**REVIEW AND CRITIQUE OF THE NRC/CNWRA
SCENARIO METHODOLOGY USED IN IPA PHASE 2**

**Nuclear Regulatory Commission
Contract NRC-02-88-005**

**Center for Nuclear Waste Regulatory Analyses
San Antonio, Texas**

December 1993

Figure 3-1. Logic diagrams for: (a) description; and (b) consequence of climate change as implemented in IPA Phase 2

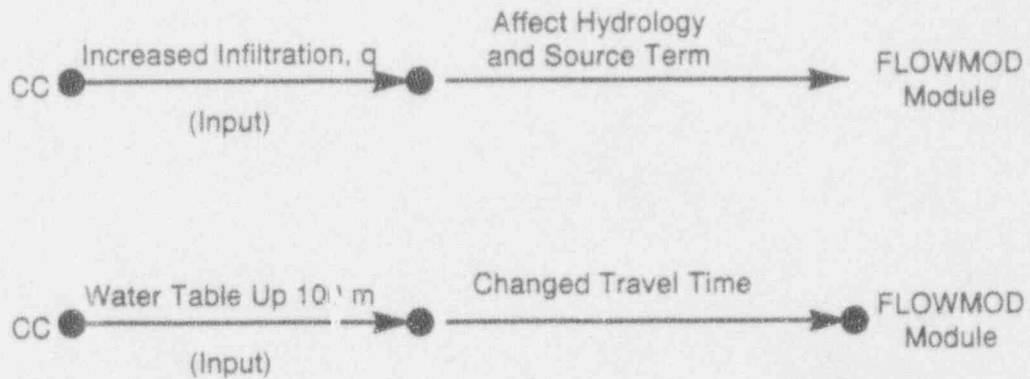
There is no provision in the TPA code for time-varying infiltration, as steady-state conditions are assumed to exist at all times. This restriction on the basic capability of the code implies that the climatic model can only consider steady-state conditions.

Moving toward a capability for time-varying climatic changes was addressed using expert elicitation in a recent report by DeWispelare et al. (1993). Five experts in climatology were assembled, and each provided opinions on climate at Yucca Mountain over the next 10,000 yr. For the categories of average temperature, winter and summer precipitation, maximum precipitation over a decade, and cloud cover, each expert provided expected values and 95 percent confidence bounds for 100, 300, 1000, 3000, 5000, 7500, and 10,000 yr in the future. Although this exercise was mainly a demonstration of expert elicitation procedures, this information can be used to estimate time-varying probability distributions of rainfall for use in future modules. Prediction of net infiltration from this information, however, would need to be performed.

- investigate the linkages between climate and infiltration

Modeling of these effects should provide a more defensible model of infiltration rate which has been found to be an important parameter in both IPA efforts (U.S. Nuclear Regulatory Commission, 1992; 1993).

Figure 3-2. Logic diagram summarizing the description of volcanic events implemented in IPA Phase 2

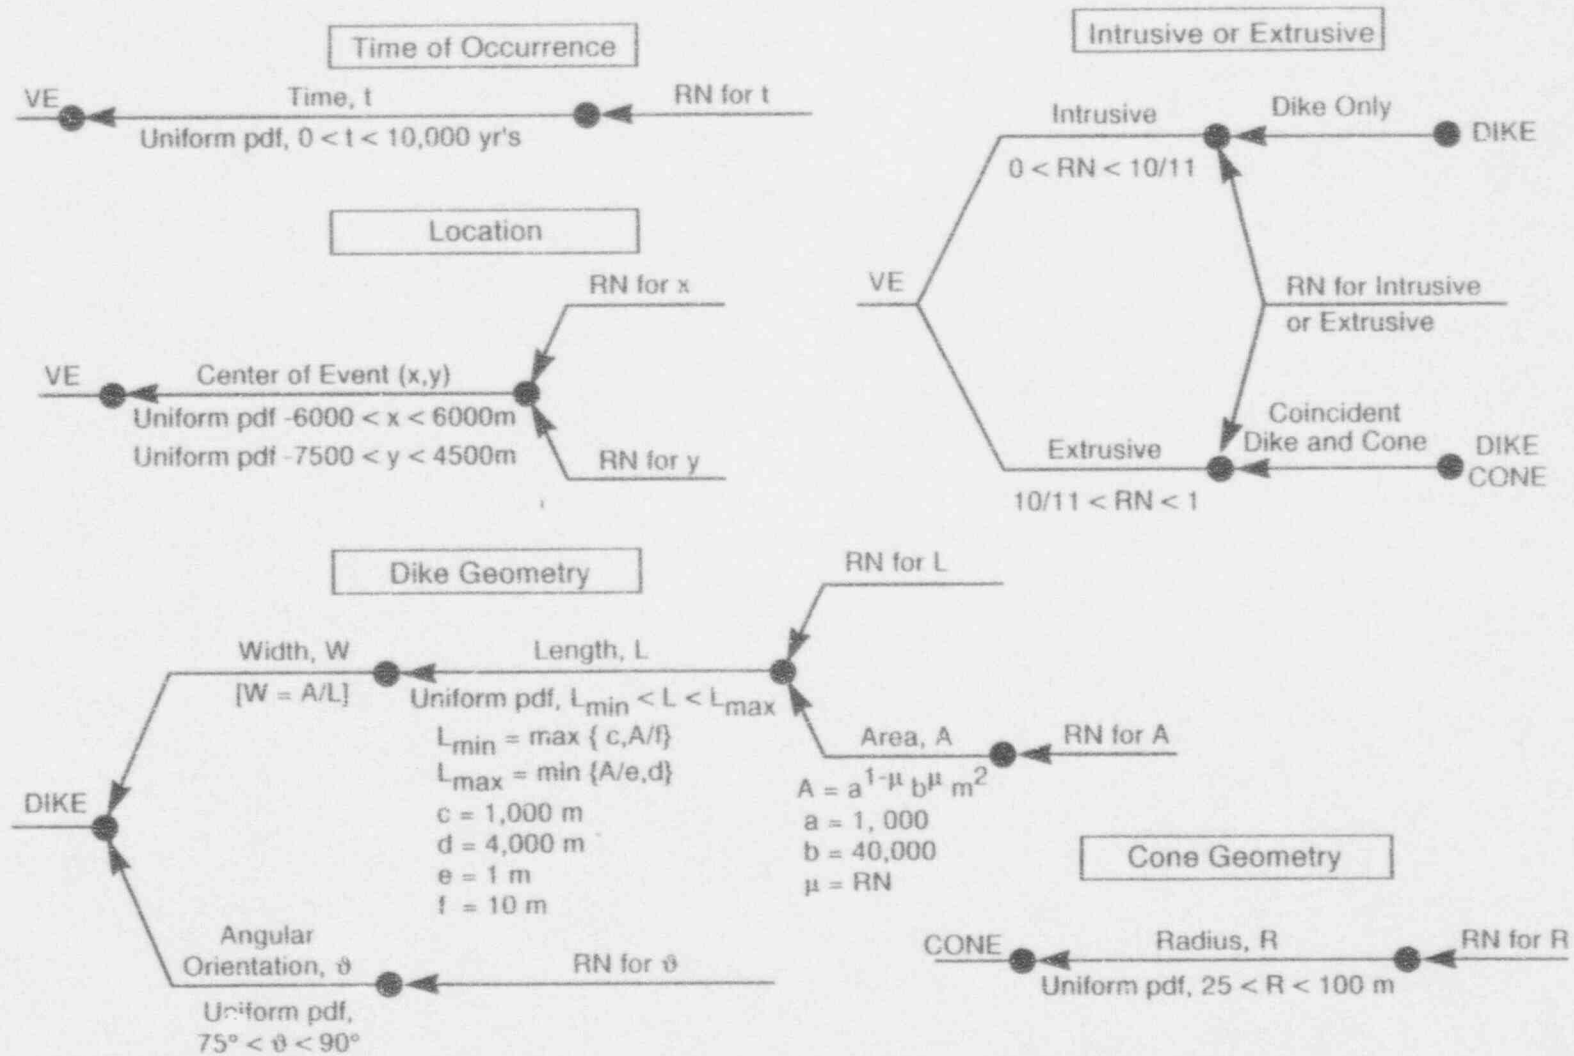
The time of occurrence is determined by a random number (denoted as RN in Figure 3-2) which is used to sample from a uniform PDF yielding times from 0 to 10,000 yr. Similarly, the location is determined by random sampling from uniform PDFs for both x and y. Intrusive disruptions are considered 10 times more likely than extrusive disruptions. For intrusive events, only a dike is considered. For extrusive events, a coincident dike and cone are considered. The dike geometry is described by width, length, area (area equals the product of width and length), and orientation angle measured from the east and rotating to the north. The cone geometry is described by a radius which is selected from a uniform PDF from 25 to 100 m.

The current IPA Phase 2 implementation requires a significant number of random numbers to describe the size, location and geometry of an event. The heavy reliance on random numbers is a distinction from the event-tree scenario implementations (e.g., Cranwell et al., 1990; Barr and Dunn, 1993). In event-trees, the events are described without reliance on random number generators (which are

The following improvements are recommended for the VOLCANO module:

- Increase usage of volcanologic experts to generate conceptual and mathematical models of volcanic events and their consequence. In particular, the expert(s) should either concur or improve estimates of:

Figure 3-5. Logic diagram summarizing the description of drilling events as implemented in IPA Phase 2

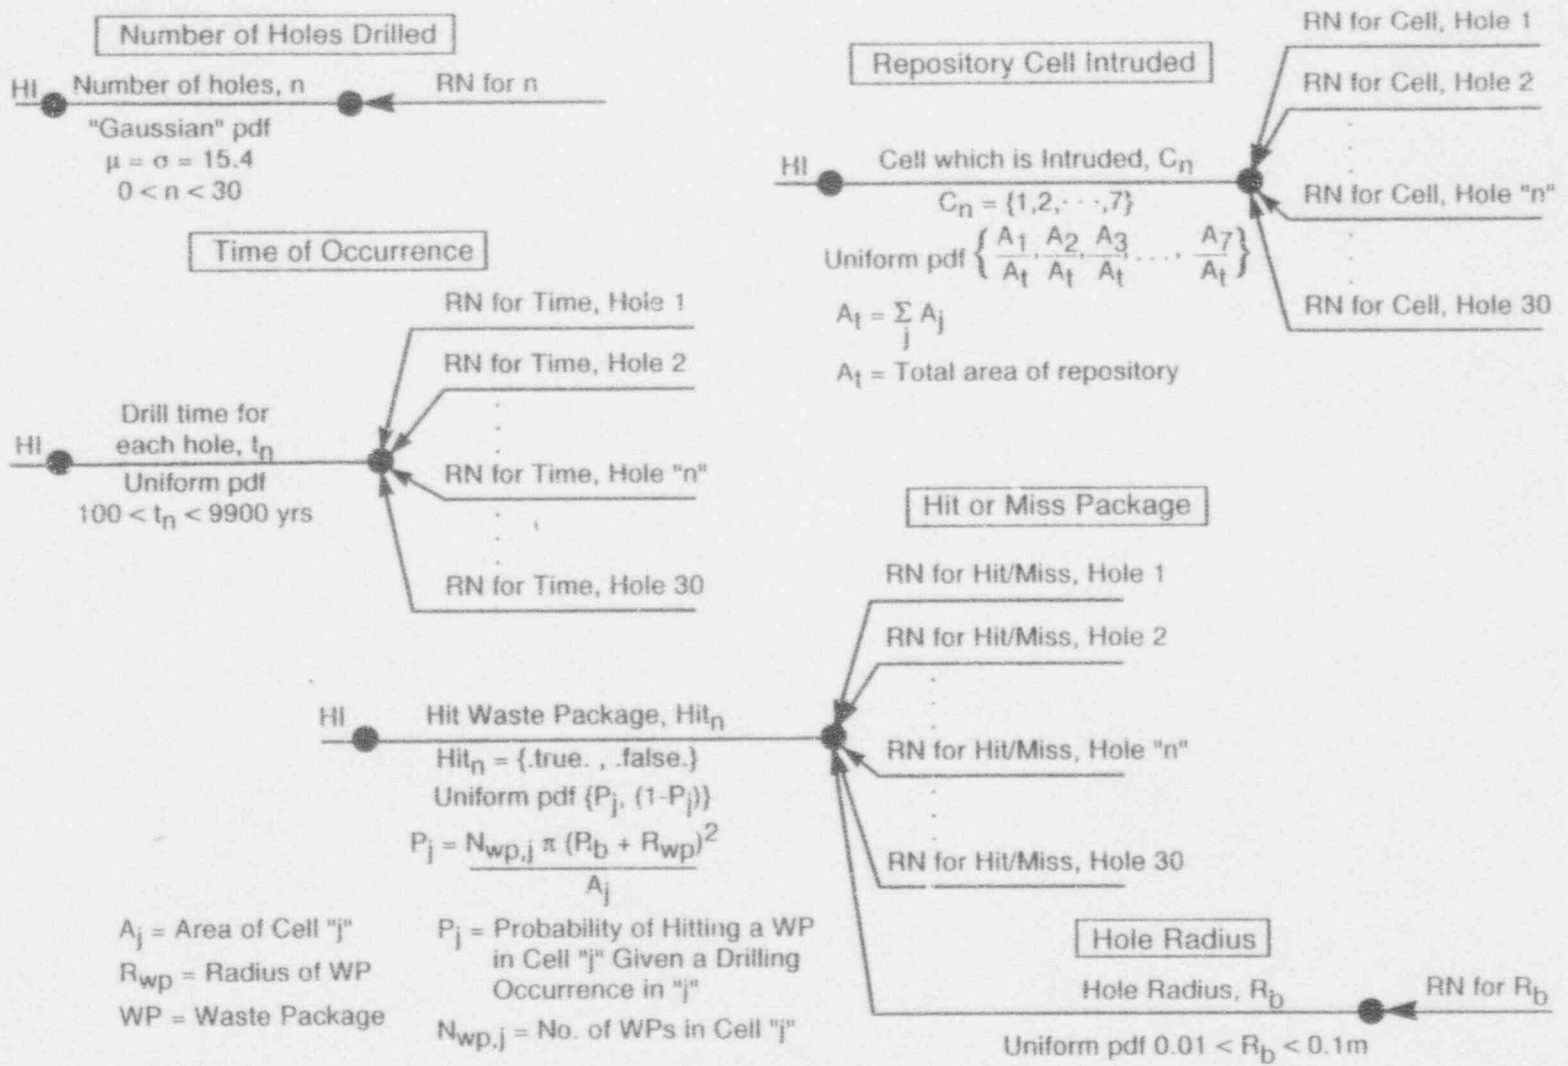
As implemented, the DRILLO module requires 92 random numbers to fully describe a realization of drilling events. It should be noted that many of the random numbers are not used in the simulation because only the first n are used to determine time of occurrence, hit or miss, and cell intruded.

Figure 3-9. Logic diagram summarizing both the description and consequence of seismic events as implemented in IPA Phase 2

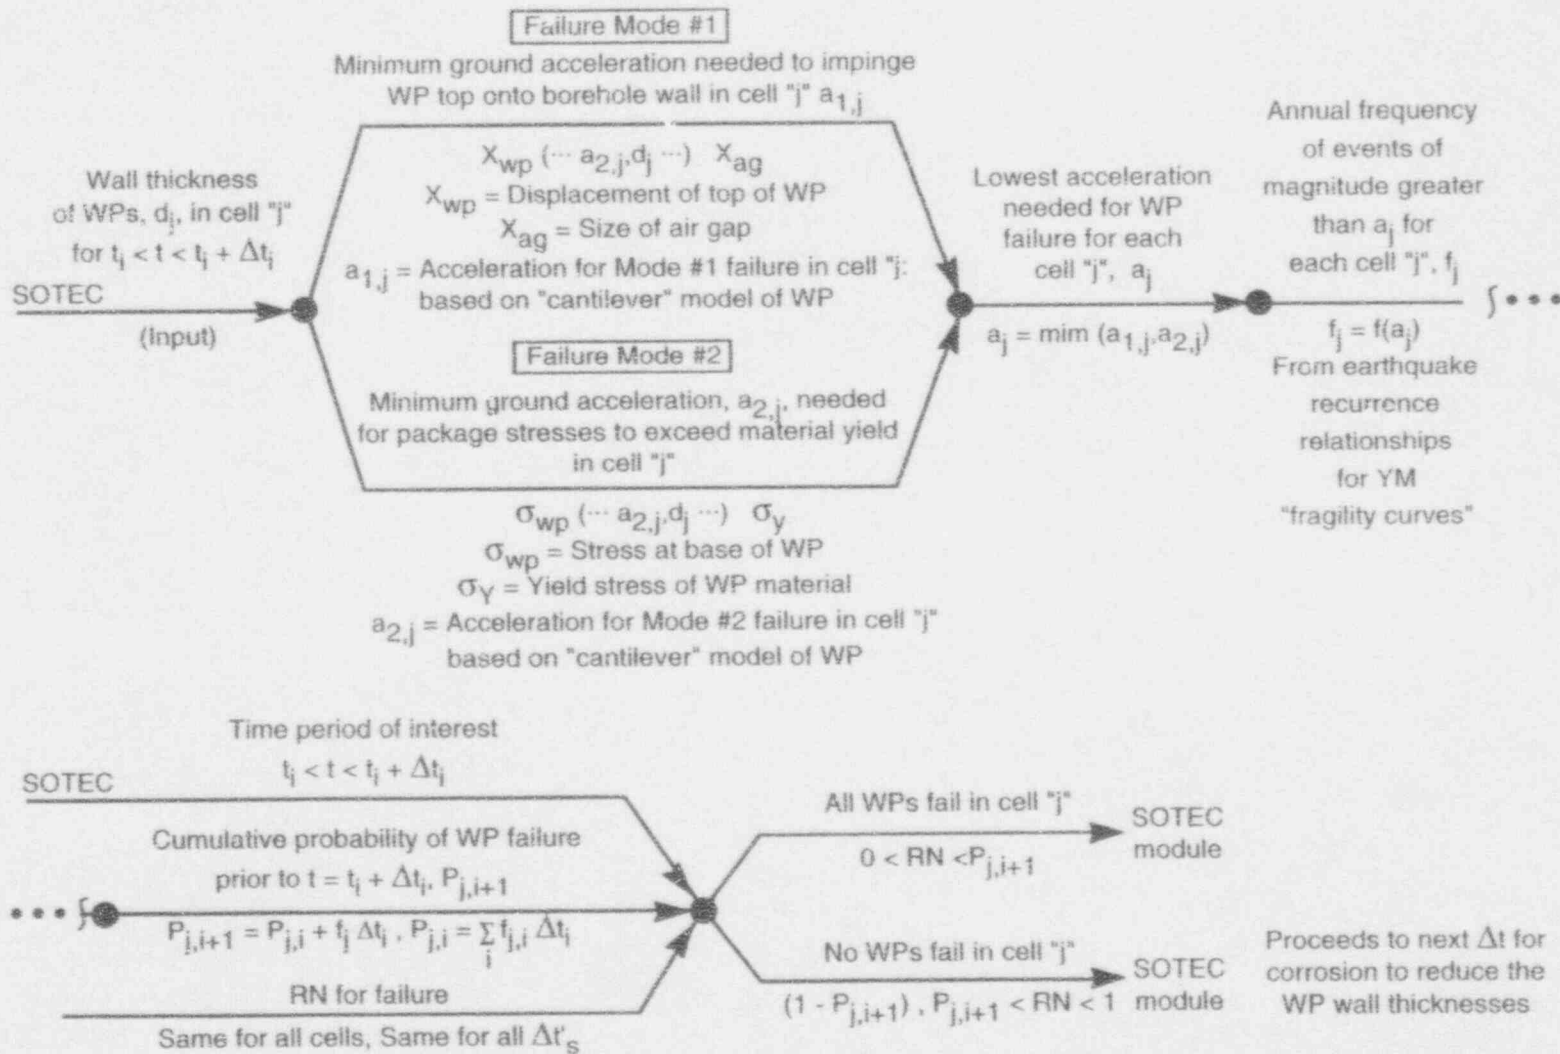
A logic diagram for the SEISMO module is presented in Figure 3-9. The logic diagram has more information about the implementation details than the flow diagram. Either the logic or flow diagram are useful to graphically describe the SEISMO module. The logic diagram is one long connected stream which is very similar to the flow diagram. Frequently, the description of a disruptive event is more easily presented using a logic diagram, and the consequence is more easily presented using a flow diagram. For this module, however, there is no clear distinction between description and consequence. The implementation is based on an engineering analysis which calculates the time of failure. Hence, the current implementation does not emphasize the uncertainty associated with the future-state of the repository. The uncertainty is implemented in the random number used to determine the time of failure due to the cumulative waste package failure probability. As implemented, this uncertainty could be

interpreted as modeling the uncertainty in the seismically sensitive, corrosion-reduced thickness of the waste package, or another parameter.

- aseismic effects, especially along the Ghost Dance fault
- secondary faulting effects
- seismic effects on seals for shafts/ramps
- seismic effects on near-field hydraulic conductivity which may provide preferential flow paths for increased infiltration and/or radionuclide transport
